MUNICIPALITY of the
COUNTY of KINGS

MEMORANDUM

To:	Prospective Bidders NRFP#23-01 Regional STP Cell 1 Desludging	From:	Scott Quinn, P. Eng. Director, EPW Lands and Parks
CC:	Abdelkhalek Omar, P. Eng., Manager of Engineering Services Aaron Dondale, Manager of Operations		
Subject:	Addendum #3	Date:	January 23, 2023

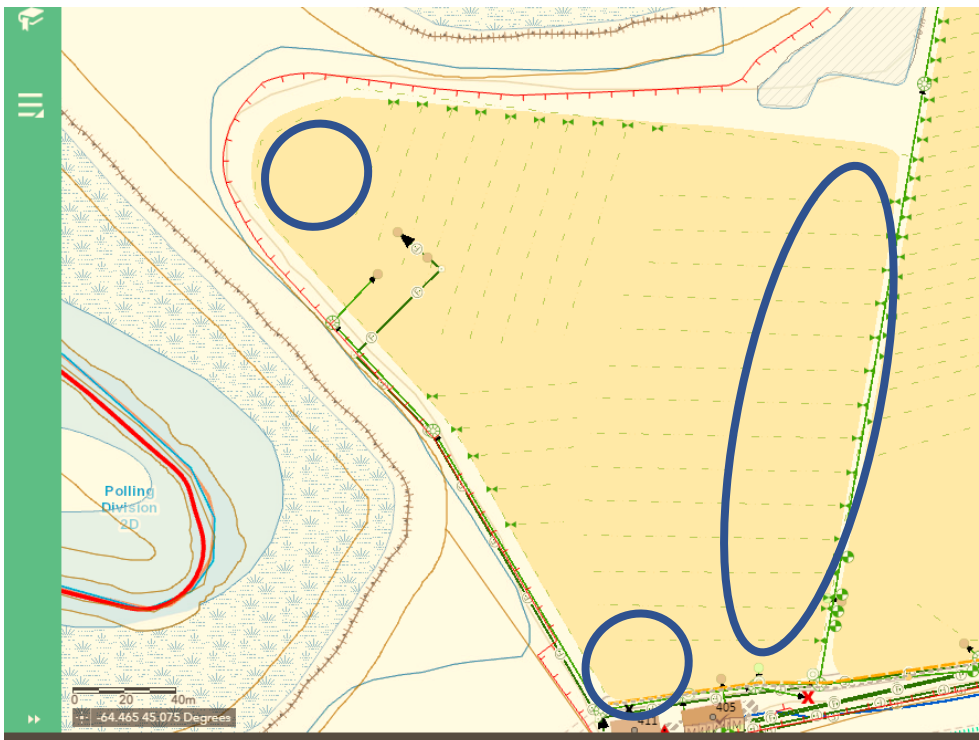
1. **Question:** *Project timelines. Existing laydown adjacent to Cell 1 is allotted for dewatering of Cell 2 in the awarded contract. Additional area will need to be constructed for dewatering process of Cell 1. Where is this?*

Response: Two potential areas are noted in the aerial image below, the area noted on the left of the image would require fence reinstatement. Other areas near Cell 1 may also be considered.
